STATE OF NORTH CAROLINA
DEPARTMENT OF TRANSPORTATION

Subject: **Supplement to the Nationwide 23 and 33 applications**, submitted on August 15, 2003, for the replacement of Bridge No. 404 over South Potts Creek on SR 1147, Davidson County. Federal Aid Project No. BRSTP-1147(3), State Project No. 8.2604401, TIP Project No. B-4334.

NCDOT
 DIVISION OF HIGHWAYS
 DAVIDSON COUNTY
 PROJECT: 8.2604401 (B-4334)
 REPLACE BRIDGE NO.404
 OVER SOUTH POTTS CREEK
 ON SR 1147

SHEET 3 OF 6
 10/27/05
Revised

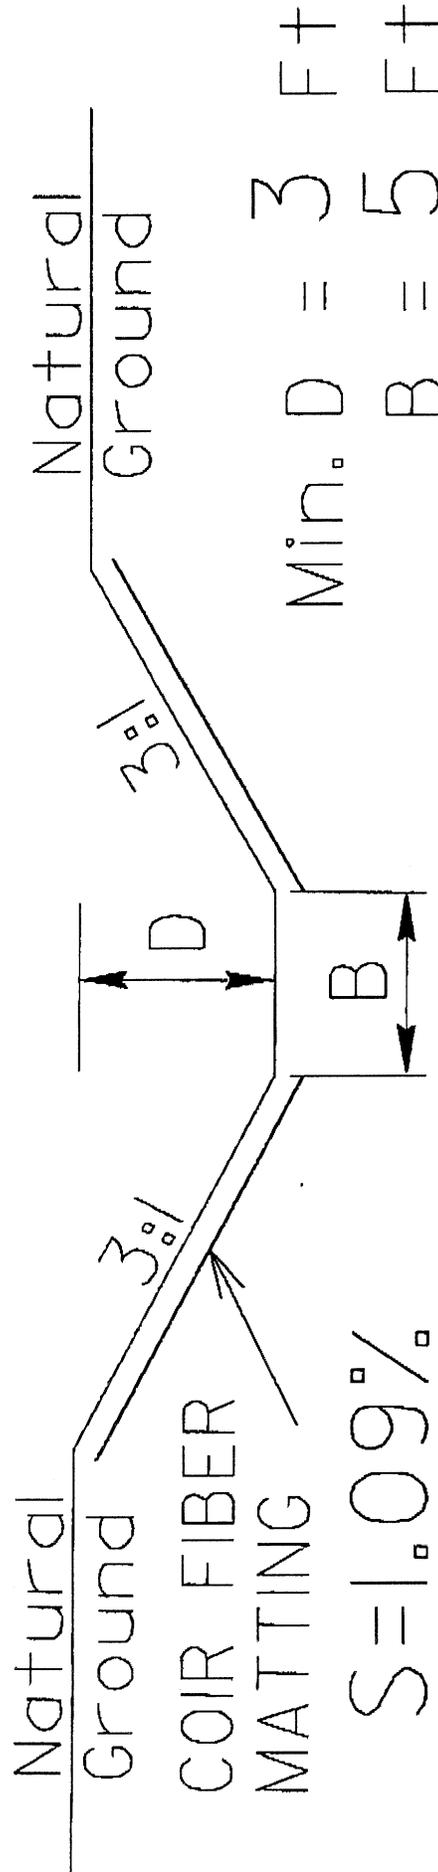
The USACE requested that the NCDOT provide more information on the length of proposed relocation, how the relocation of the unnamed tributary was designed, if the relocation is within the Right-of-way, how the NCDOT plans on stabilizing the stream, and a planting plan. A revised permit sheet 3 has been included showing a cross section of the relocation, sheet 3B showing the stream relocation at a larger scale, sheet 3C showing how the channel block will be constructed and a revised summary sheet. The above mentioned questions are answered below.

Currently, the unnamed tributary meanders around the existing interior bents of the existing bridge. The interior bents of the new bridge would impact the existing stream. There is no other practical place to put the bents due to underground structures. Therefore, the stream will be relocated to avoid the interior bent from the new bridge.

The stream relocation for the 56-foot portion of the unnamed tributary to South Potts Creek was designed to match the existing stream cross sectional area of 35 square feet. The entire portion of the stream relocation is located within the proposed right-of-way. The proposed stream has a cross sectional area of 42 square feet. The area is slightly larger because 3:1 side slopes were used to decrease erosion. Coir fiber matting will be used to stabilize the side slopes of the stream relocation. The five-foot base width and three-foot depth of the proposed stream is the same as the existing stream. The drainage area for the stream is 3.63 square miles. Using the Manning equation for the open channel hydraulics for a stream section with a five-foot base, 3:1 side slopes, three-foot depth and a slope of 1.09 percent, yields a discharge of 210 cubic feet per second with a velocity of 5.0 feet per second. The 2 year discharge calculated using the USGS Report 01-4207 for the Rural Blue Ridge-Piedmont region yields a discharge of 330 feet per second. The area surrounding the stream relocation will be seeded with grasses to minimize erosion.
